**UNITED STATES DEPARTMENT OF COMMERCE  
Patent and Trademark Office**

09/115,764    07/15/98    REASONER    M    65.748-449

# Office Action Summary

☒ This action is **FINAL**.

NOTE THAT L1 IS SHORTER THAN L2 AS MEASURED BY A RULER  
EXHIBIT - I

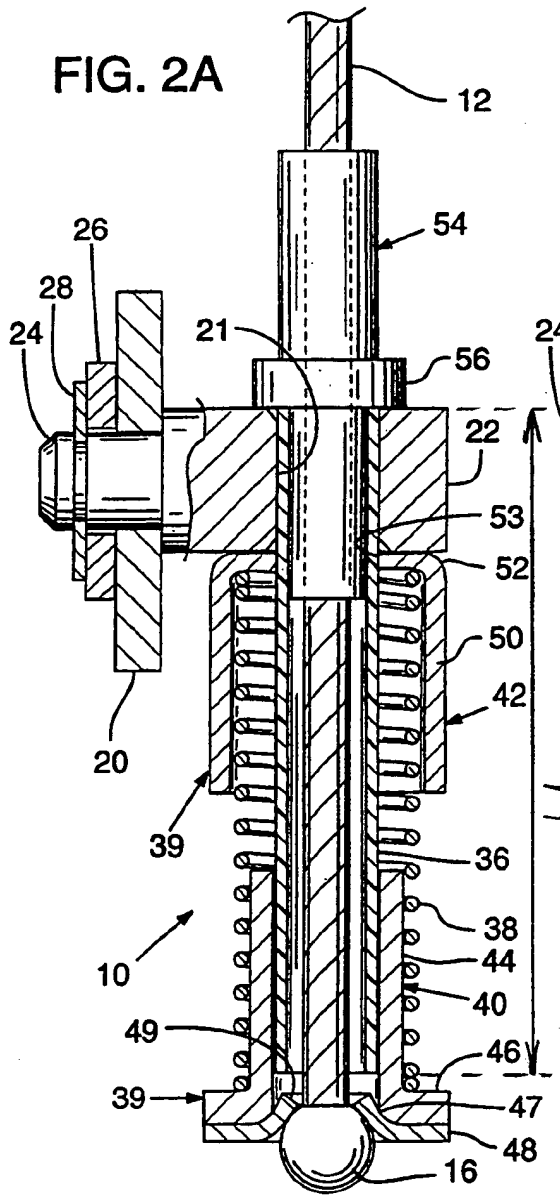
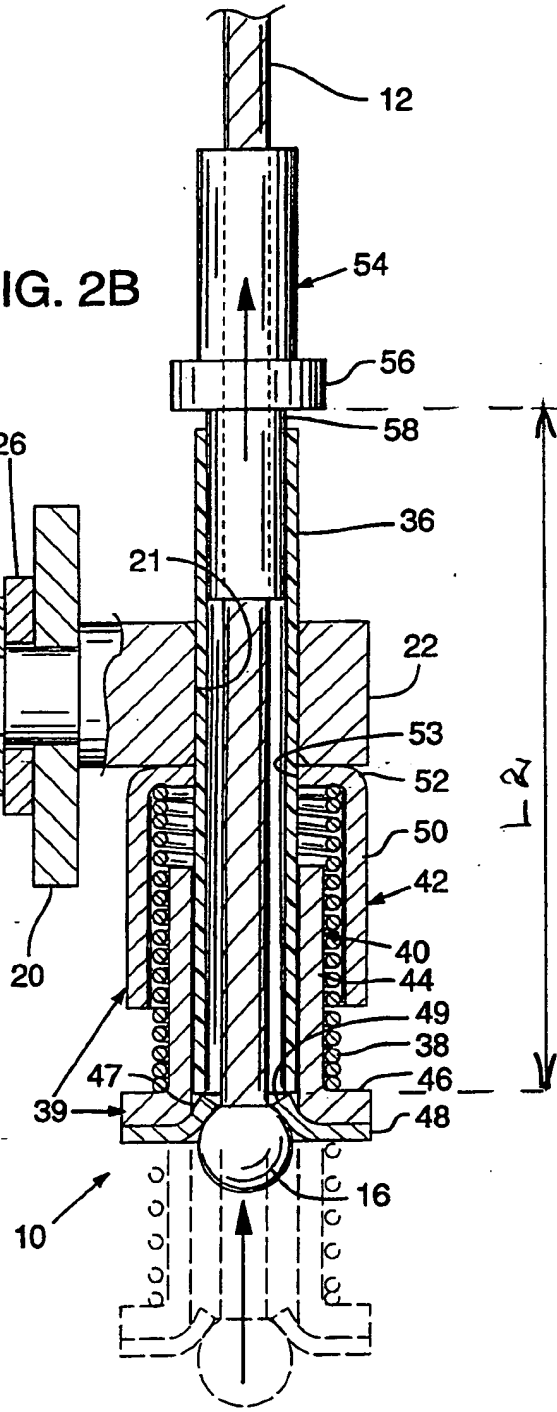
a retainer (a protruding flange) 52 for retaining the spring 38 (i.e., as a seat for the spring 38. *Ibid.*, column 4, line 49 *et seq.*) in compression on one of the members 40 and 42, the members 40 and 42 including an abutment 46 for reacting with the spring 38 in place of the retainer 52 to bias the members 40 and 42 together in the direction to shorten the overall length of the conduit sections 36 and 58 as seen in the Exhibit I attached.

Regarding claim 17, as the spring 38 is compressed axially (Fig. 2B), the first conduit 36 is pulled and the second conduit 58 (i.e., the fitting 54) moves away, consequently, the overall length of the conduit sections 36 and 58 are inherently lengthened. See lines 18-30 of column 7. Further, as the spring 38 is expanded axially (Fig. 2A), the first conduit 36 is retracted backwardly and the

second conduit 58 (i.e., the fitting 54) moves forwardly until the fitting 54 is stopped by the pivot coupling 22, consequently, the overall length of the conduit sections 36 and 58 are inherently shortened. See lines 47-53 of column 7 and the Exhibit I.

Applicant's Modified Exhibit likewise missed the point because the examiner did not call the fitting 54 as the conduit section as applicant alleged. As plainly seen in the Exhibit attached, the conduit sections 36 and 58 are shortened as fully explained in the Office action on August 16, 1999.

EXHIBIT - II

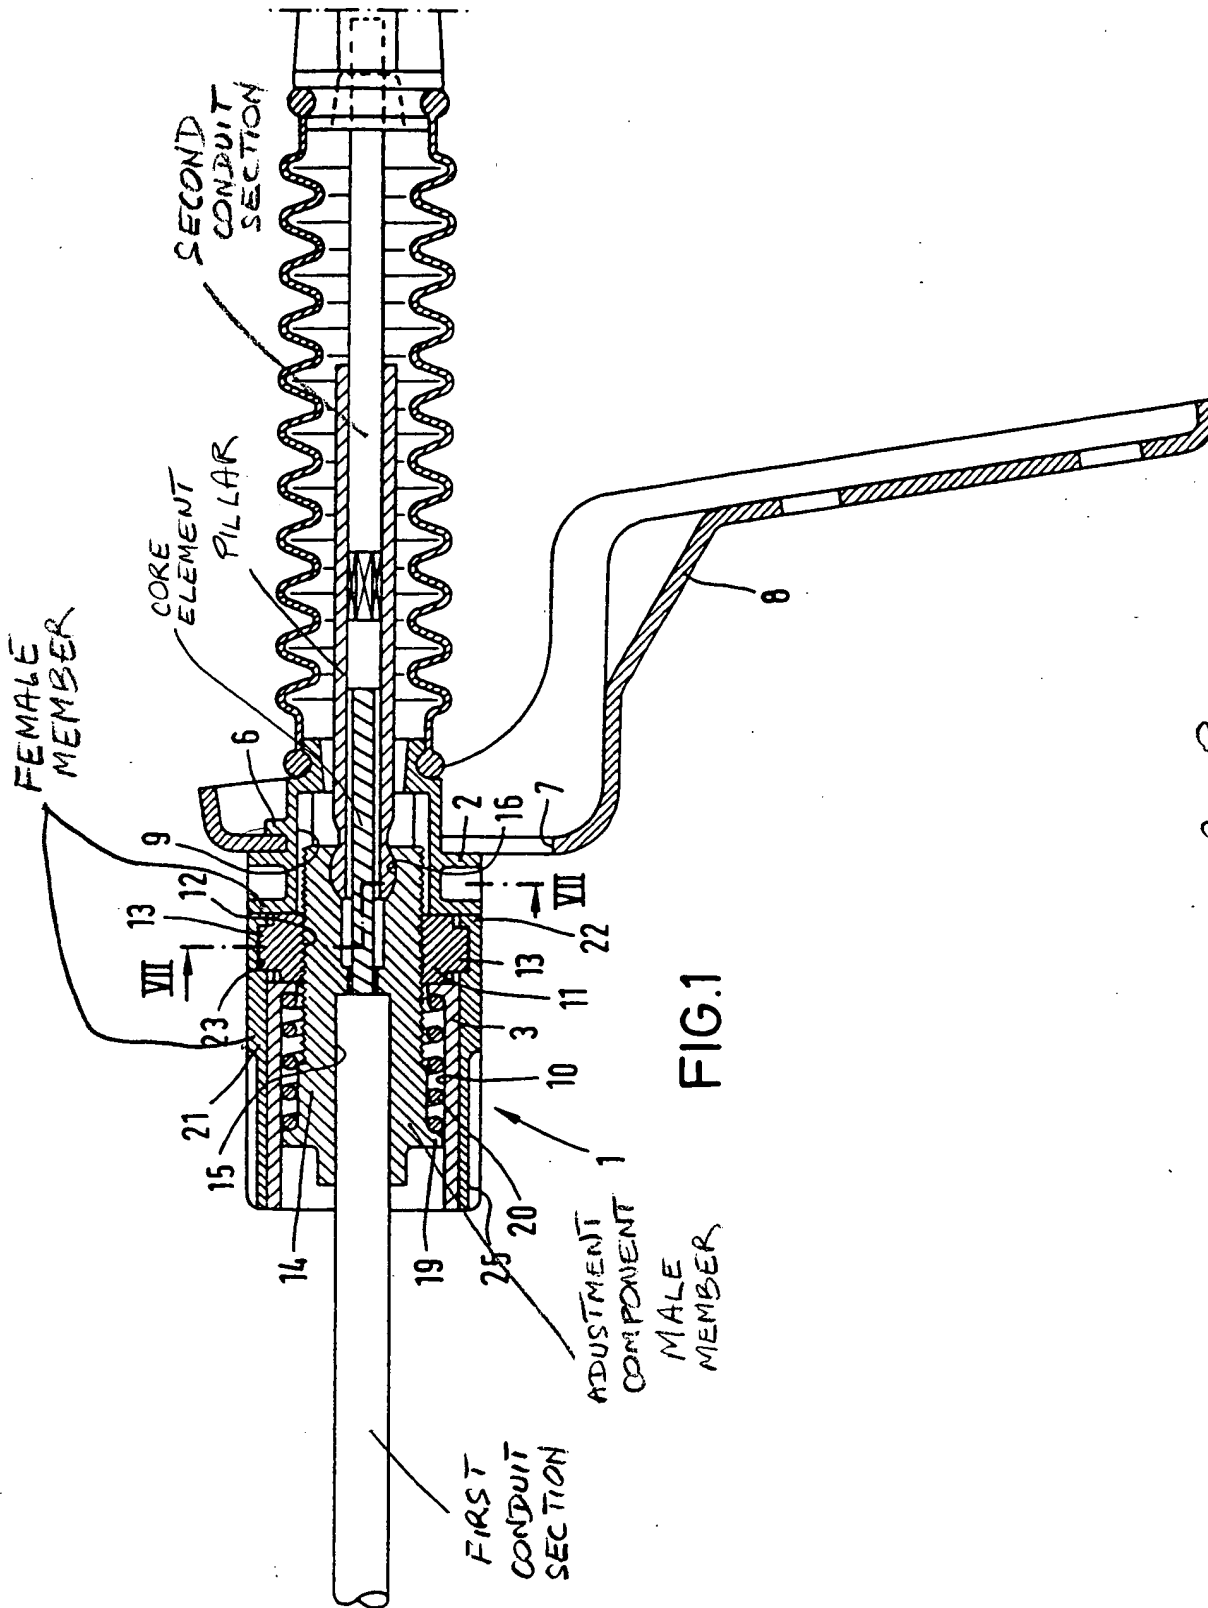
first and second conduit sections (*i.e.*, the Bowden cable sheath. *Ibid.*, line 63 et seq., column 2. See the Exhibit II attached);

a flexible motion transmitting core element (see Exhibit II) movably supported in the conduit sections;

a pillar (see Exhibit II) extending into the adjustment components 14 and 21, 6 and having a bore therethrough for receiving the core element; and

Note that although Adams does not show the shortening of the overall length of the conduit sections in the same manner as the applicant, however, when the length of the cable of Adams is releasably fixed, the overall length of the conduit sections of Adams is inherently shortened because the biasing force of the spring 20 eliminates the slacks in the conduit sections. Applicant's claim is anticipated by Adams under the principle of inherency. It is well settled that the functional limitations of a claim may not be given patentable weight where those limitations are inherent in a prior art reference. *In re Schreiber, supra.*

Regarding claim 39, the male member 14 presents an internal limit surface 16 for engaging an inner end of the pillar to limit the insertion of the male member into the female member as seen in the Exhibit II.
